Wisconsin Department of Transportation

NOTICE TO ALL CONTRACTORS:

Proposal #07: 2030-14-70, WISC 2018 086
108th St, City of West Allis
Hank Aaron State Trail, B-40-107/108
STH 100
Milwaukee County

This is Addendum No. 01, which provides for the following:

Addendum No. 01
 ID 2030-14-70
 Revised Sheet 7
 February 6, 2018

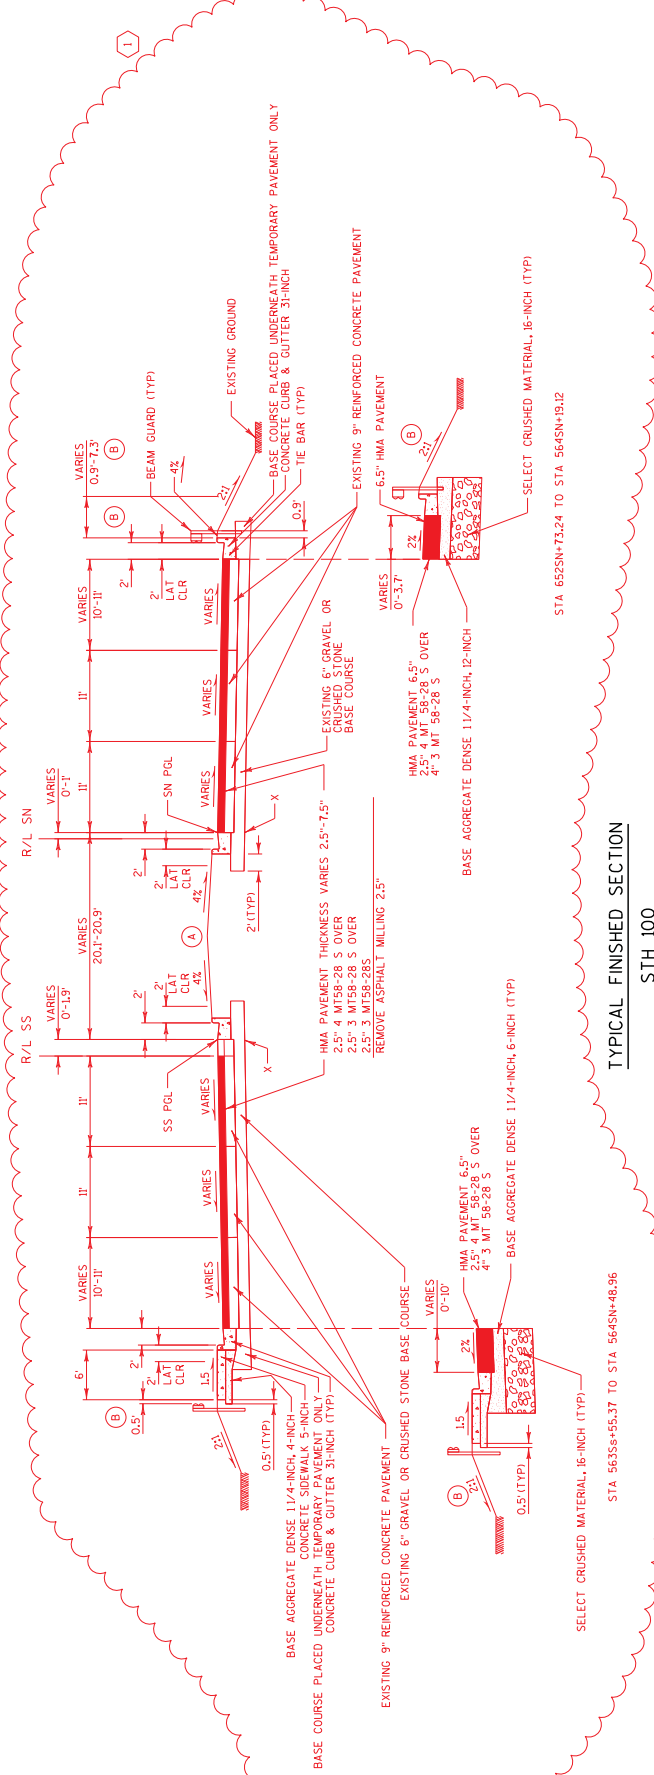
Revised Plan Sheets	
Plan Sheet	Plan Sheet Title (brief description of changes to sheet)
3	Revised General Notes, HMA Pavement Table, and Order of Section 2 Detail Sheets
7	Revised Pavement Structure, Reconstruction Limits, and Concrete Pavement Type
8	Revised Concrete Pavement Type
10	Revised Pavement Structure, Reconstruction Limits, and Concrete Pavement Type
11	Removed Detail for Matching Existing Pavement at BOP
18	Revised Removing Pavement, Removing Curb & Gutter, and Asphaltic Surface Milling Limits
21	Revised Pavement Structure, Reconstruction Limits, and Pavement Types
22	Revised Pavement Structure, Reconstruction Limits, and Pavement Types
23	Revised Pavement Surface Grades
29	Revised Storm Sewer Structure Rim Elevations
41	Revised Stage 2A – Eastbound Exit Ramp Closure
60	Revised Stage 2A – Eastbound Exit Ramp Closure
71	Revised Stage 2A – Eastbound Exit Ramp Closure
74	Revised Stage 2A – Eastbound Exit Ramp Closure

Addendum No. 01
ID 2030-14-70
Revised Sheet 254
February 6, 2018

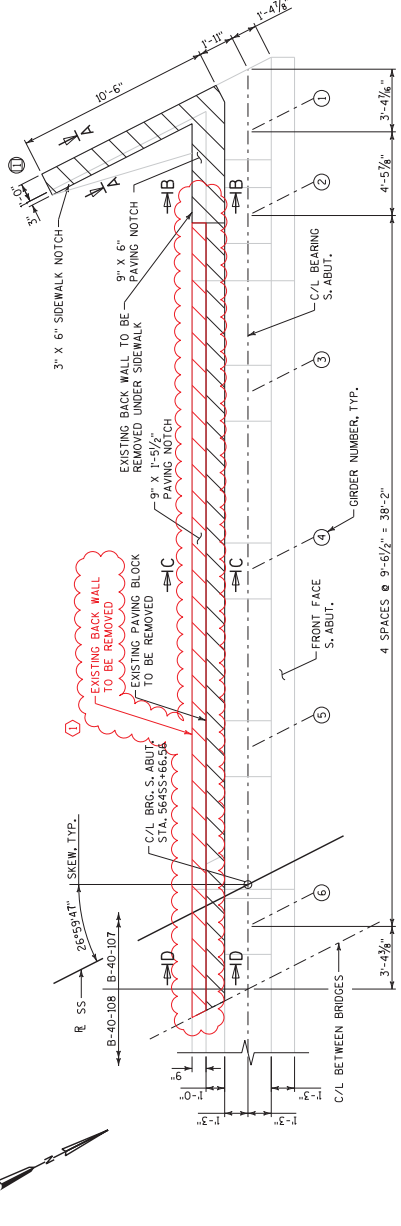
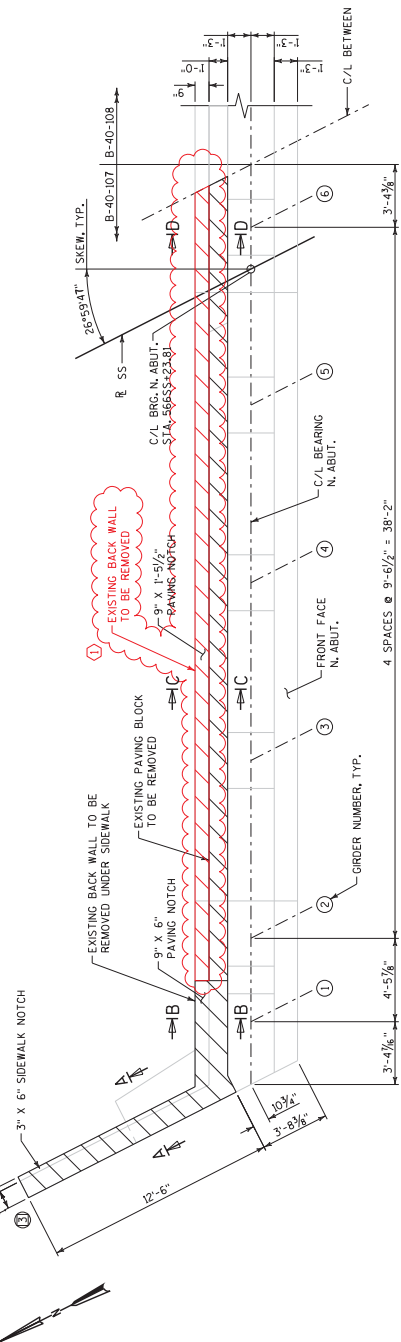
89	Revised Removal Quantities
91	Revised Sawing Quantities
92	Revised Earthwork Summary
93	Revised Aggregate and Concrete Pavement Items
94	Revised Asphalt, Dust Control, and Water Items
96	Revised Adjusting Sanitary Manhole Proposed Rim Elevation
97	Revised Storm Sewer Structure Rim Elevations
99	Revised Quantity for the Management of Solid Waste
101	Revised Traffic Control Items; New Item Added for MMSD Sanitary Sewer Televising
102	Revised Traffic Control Quantities
103	Revised Traffic Control Quantities
104	Revised Traffic Control Quantities
117	Revised Profile and Area Identifying Solid Waste Soil
118	Revised Profile and Area Identifying Solid Waste Soil
247	B-40-107 Updated List of Drawings
249	B-40-107 Revised Quantity Table
253	B-40-107 Revised Removal Limits
254	B-40-107 Revised Removal Limits

Addendum No. 01
ID 2030-14-70
Revised Sheet 288
February 6, 2018

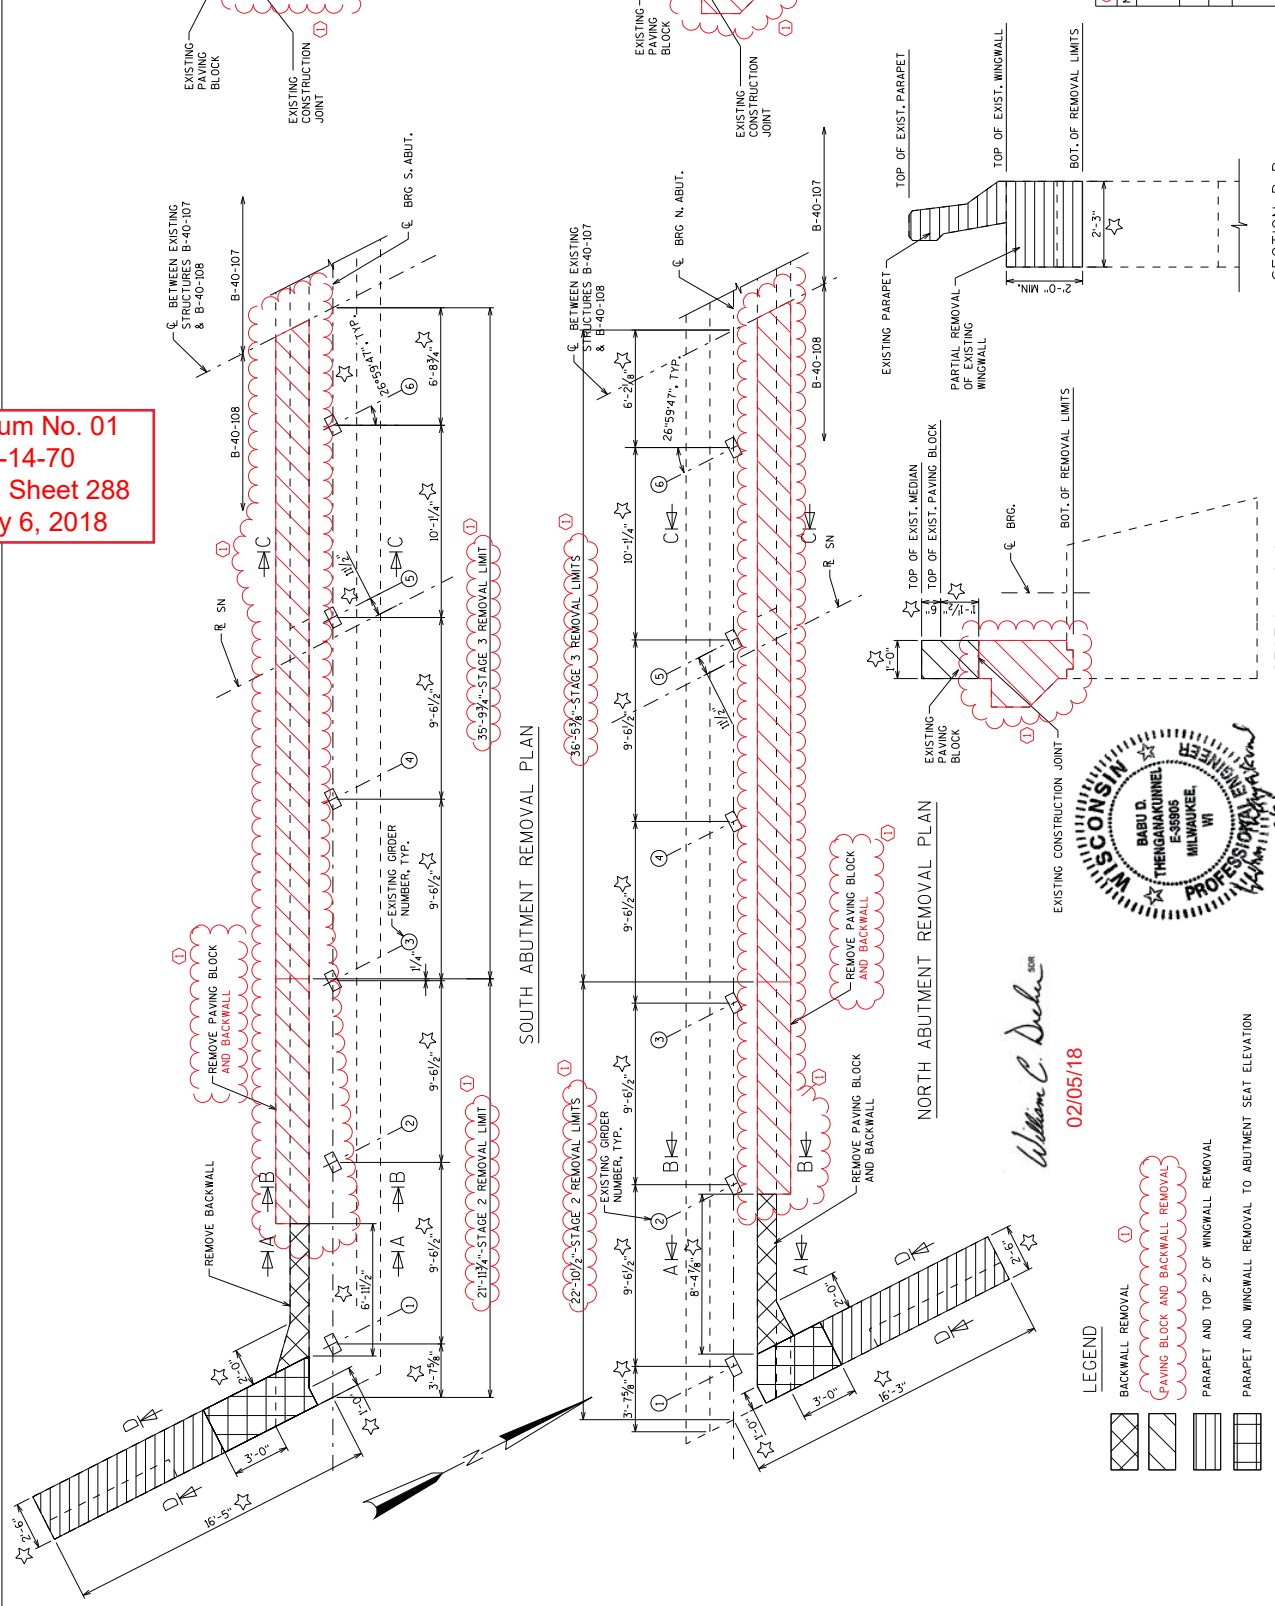
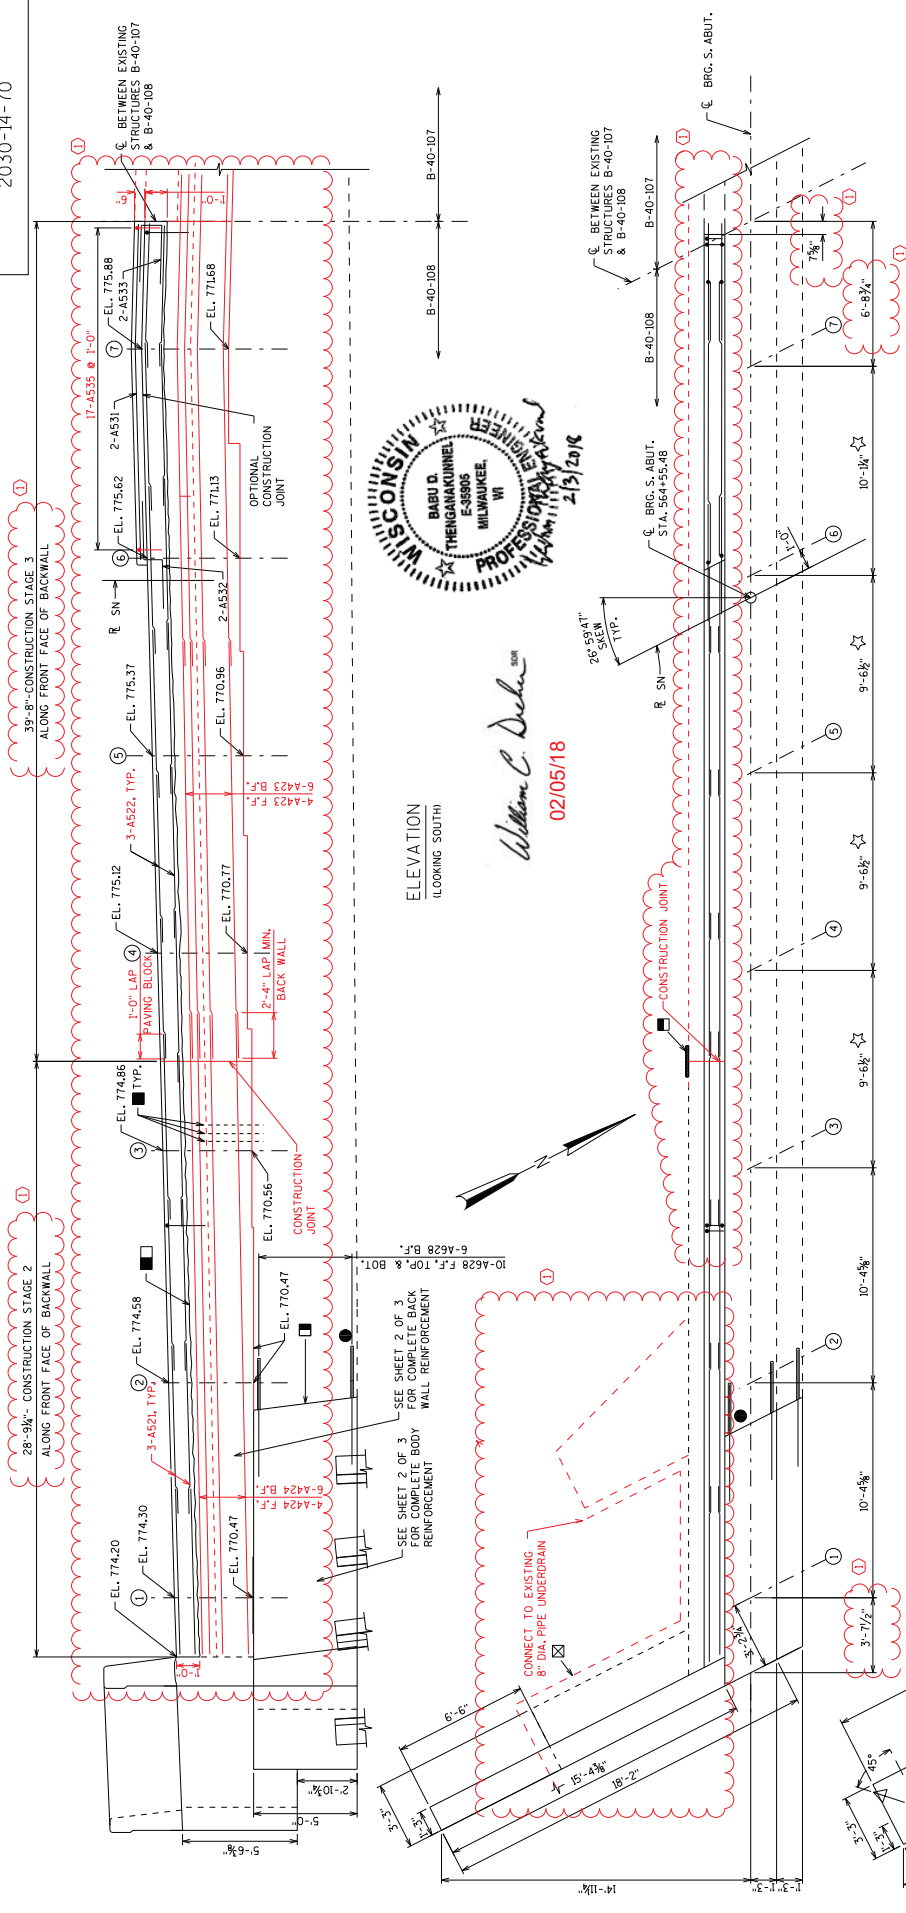
NO.	DATE	REVISION	BY
1	2/5/18	BACKWALL REMOVAL LIMITS REVISED	BOT

Addendum No. 01
ID 2030-14-70
Revised Sheet 316
February 6, 2018

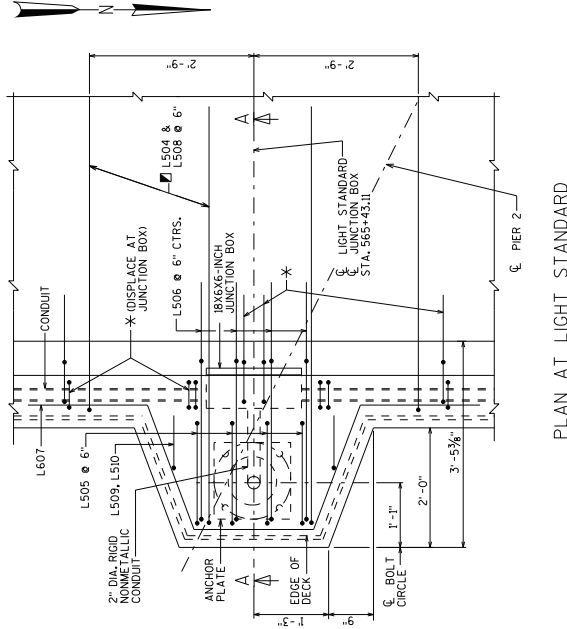
255	B-40-107 Existing Abutment Backwall Replacement
256	B-40-107 Existing Abutment Backwall Replacement
257	B-40-107 Existing Abutment Backwall Replacement
258	B-40-107 Existing Abutment Backwall Replacement
259	B-40-107 Revised Fence Post Spacing
267	B-40-107 Revised Stage Numbering
268	B-40-107 Revised Stage Numbering
270	B-40-107 Revised Stage Numbering and Abutment Backwall
271	B-40-107 Revised Stage Numbering
273	B-40-107 Revised Abutment Backwall
275	B-40-107 Revised Fence Post Spacing
279	B-40-107 Revised Fencing Details
281	B-40-108 Revised Foundation Data
282	B-40-108 Backwall Removal Note Added
283	B-40-108 Revised Quantities
288	B-40-108 Revised Backwall Removal Limits
290	B-40-108 Added Backwall Details
291	B-40-108 Added Backwall Details
292	B-40-108 Revised Bill of Bars
293	B-40-108 Added Backwall Details
294	B-40-108 Added Backwall Details
295	B-40-108 Revised Bill of Bars
316	B-40-108 Revised Bolt Circle Diameter

① 2/5/18	BOLT CIRCLE DIA. REVISED	BDT
NO.	REVISION	BY
STATE OF WISCONSIN DEPARTMENT OF TRANSPORTATION		
STRUCTURE B-40-108		
DRAWN BY	TRKMS CHD.	BDT
SHEET 36 OF 38		
316

Addendum No. 01
ID 2030-14-70
Revised Sheet 320
February 6, 2018

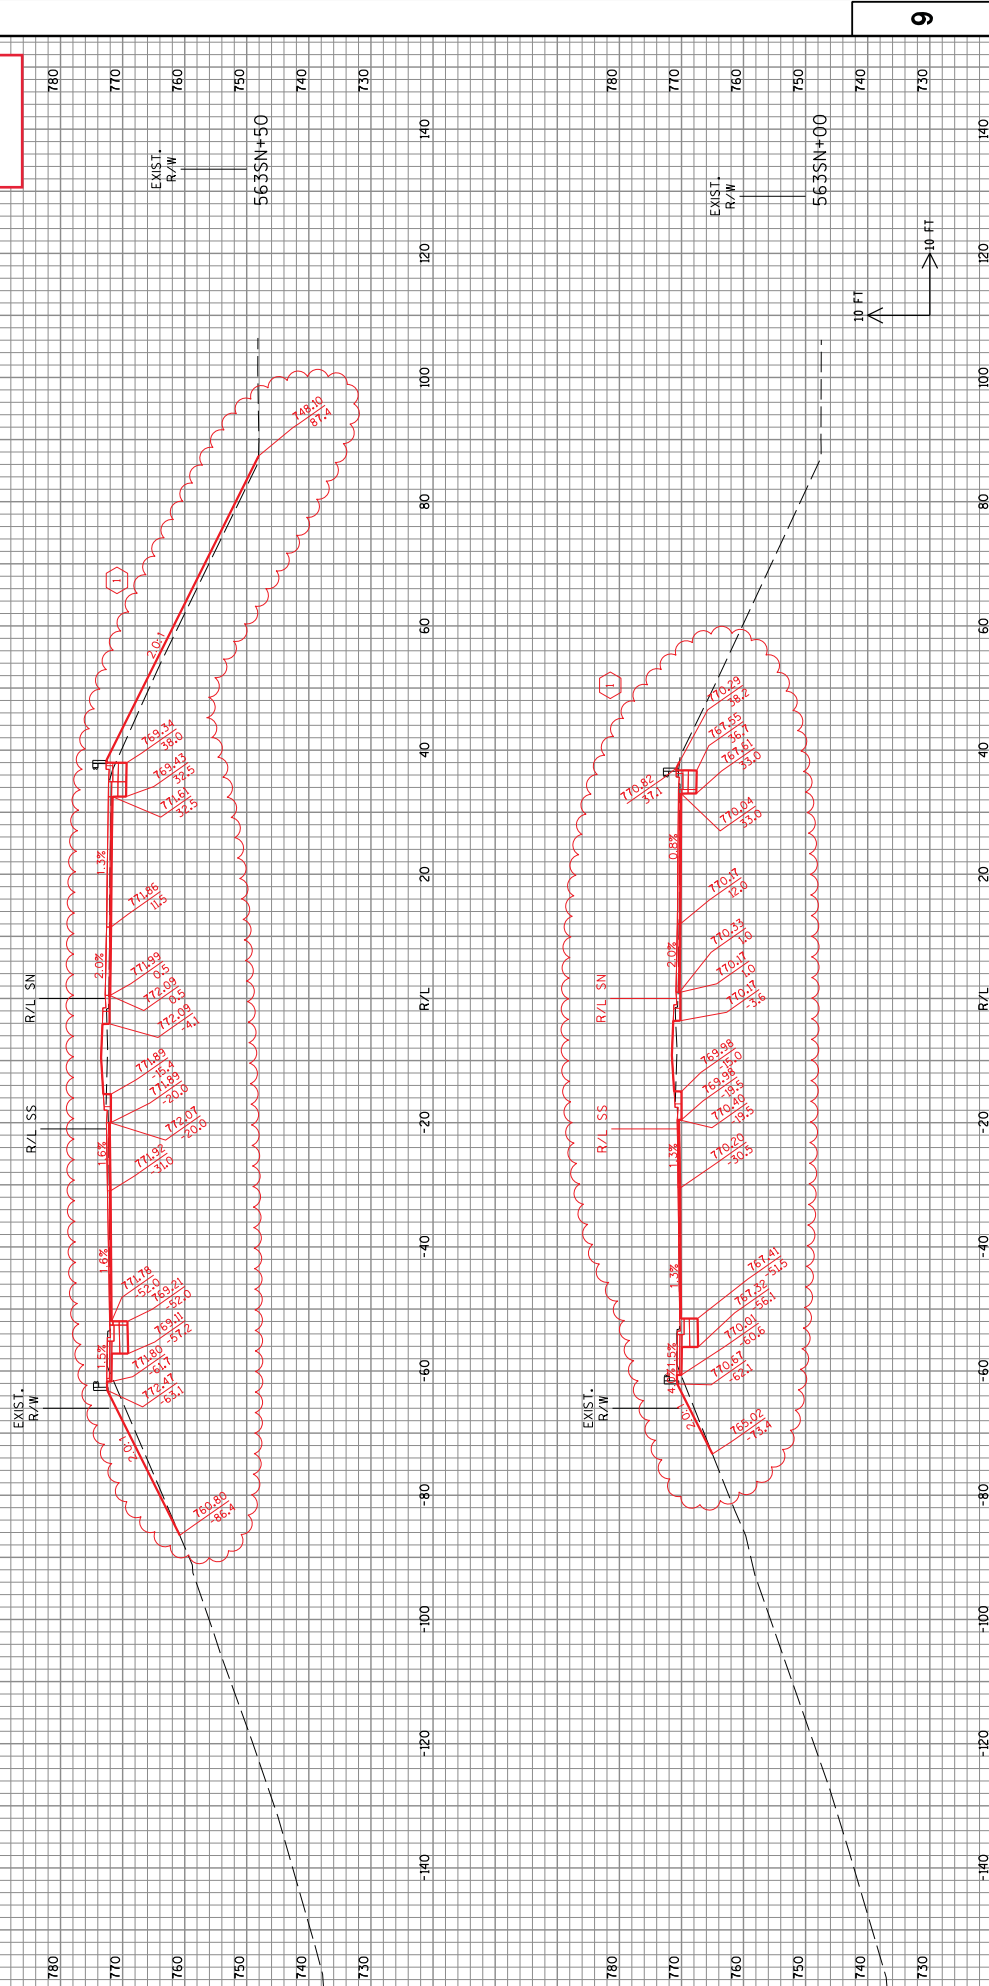
319	Revised Earthwork Data
320	Revised Pavement Structure and Reconstruction Limits
321	Revised Pavement Structure and Reconstruction Limits
322	Revised Pavement Structure and Reconstruction Limits
